Z-14
(2013)

PROJECT NAME
3014 WEST
SUBDI

ZONING PLAN
DRAWING TITLE

PETITION NO: Z-14

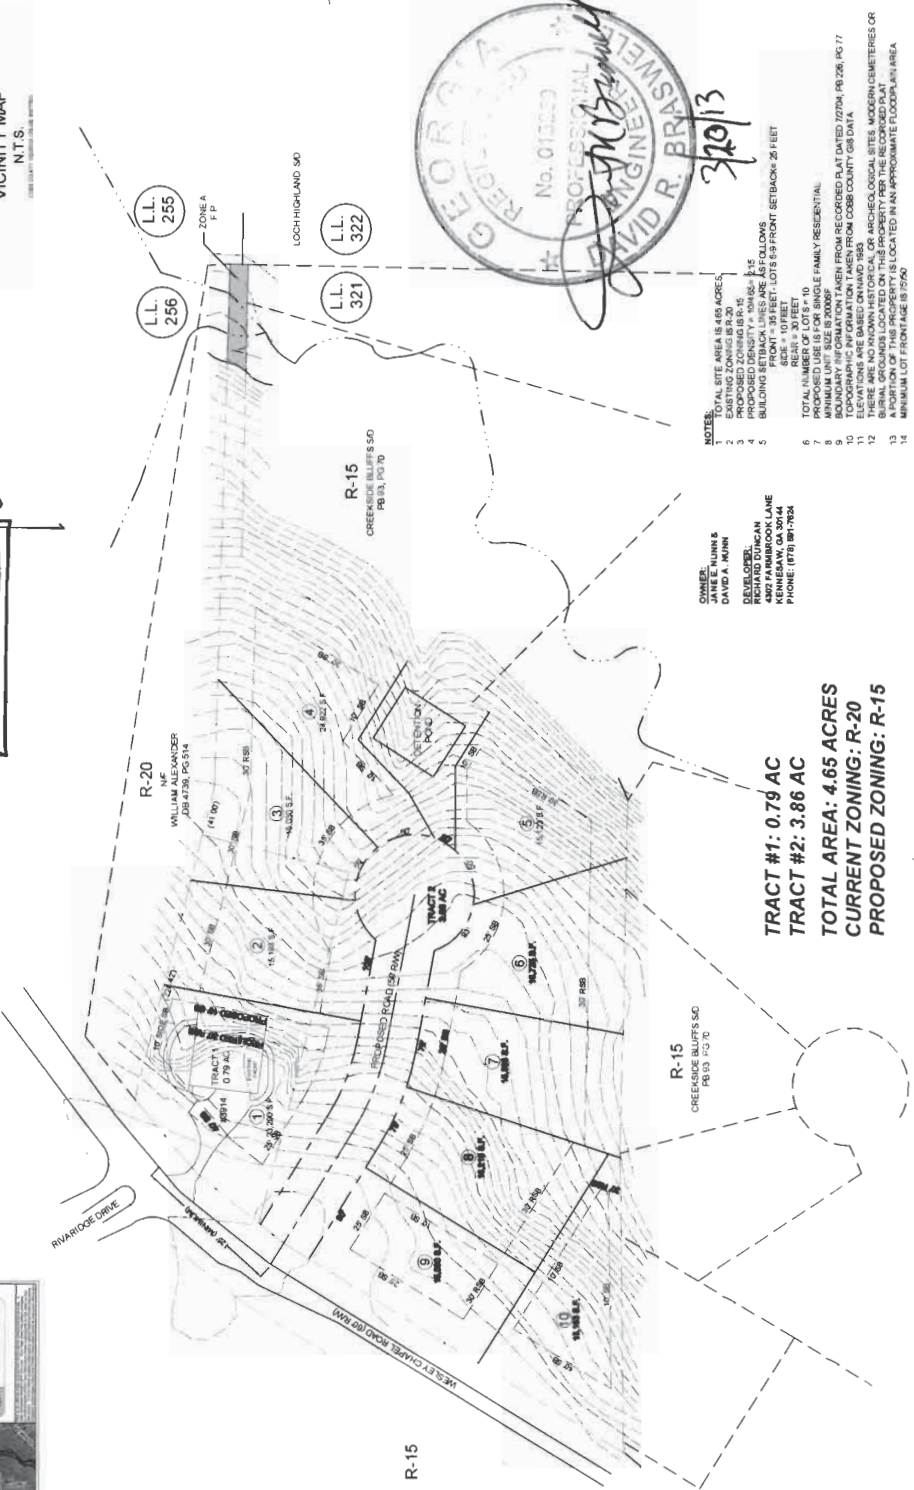
- 1. Waiving the rear setback for Lot 1 from the required 30 feet to 10 feet. This is needed due to the reconfiguration of the property for the existing house and the new lots being created; and
- 2. Waive the front setbacks for Lots 5-9 from the required 35 feet to 25 feet. In doing so, the applicant plans to move the houses forward on these lots and increase the rear setback an additional five feet to make it 35 feet.

Additional Comments: Building setback lines will be adjusted where applicable to reflect sewer easement setback requirements

- No Stormwater controls shown _____
- Copy of survey is not current – Additional comments may be forthcoming when current site conditions are exposed.
- No site improvements showing on exhibit.

1. This parcel drains to east into a tributary of Upper Loch Highland Lake which is located just downstream of the site. As indicated in the Downstream Conditions comment section, a pre- and post-development sediment survey will be required to document any sediment impacts. Also, due to the close proximity of the downstream lake elevated erosion control measures will be required. It is recommended that trees cleared from the site be mulched and used to provide a mulch berm along the eastern portion of the site during construction in addition to standard erosion control BMPs.

2. Due to the sensitive nature of the area, increased rear and decreased front setback are encouraged to limit site disturbance and impervious driveway coverage. Land disturbance on the steeper slopes at the rear of lot 5 should be limited by utilizing a drop foundation.

3. Drainage easements and adequate drainage swales must be provided at the rear of lots 4 and 5 to limit offsite runoff bypass.

Recommend applicant consider entering into a development agreement pursuant of O.C.G.A. 36-71-13 for dedication of the following system improvements to mitigate traffic concerns: a) donation of right-of-way on the east side of Wesley Chapel Road, a minimum of 30' from the roadway centerline.

Recommend curb, gutter, and sidewalk along the Wesley Chapel Road frontage.

Recommend curb and gutter along both sides and sidewalk along one side of proposed development roadway. The proposed sidewalk from the development should connect to the proposed sidewalk on Wesley Chapel Road.

Recommend development roadway either directly align or have an offset of a minimum of 125 feet from Rivaridge Drive per Development Standard 401.10.

Recommend applicant verify that minimum intersection sight distance is available for Wesley Chapel Road access and if it is not, implement remedial measures, subject to the Department's approval, to achieve the minimum requirement of 390 feet.

- Revised site plan received by the Zoning Division on March 18, 2013, with the District Commissioner approving minor modifications;
- Water and Sewer comments and recommendations;
- Stormwater Management comments and recommendations;
- DOT comments and recommendations; and
- Owner/developer to enter into a Development Agreement pursuant to O.C.G.A. §36-71-13 for dedication of system improvements to mitigate traffic concerns.
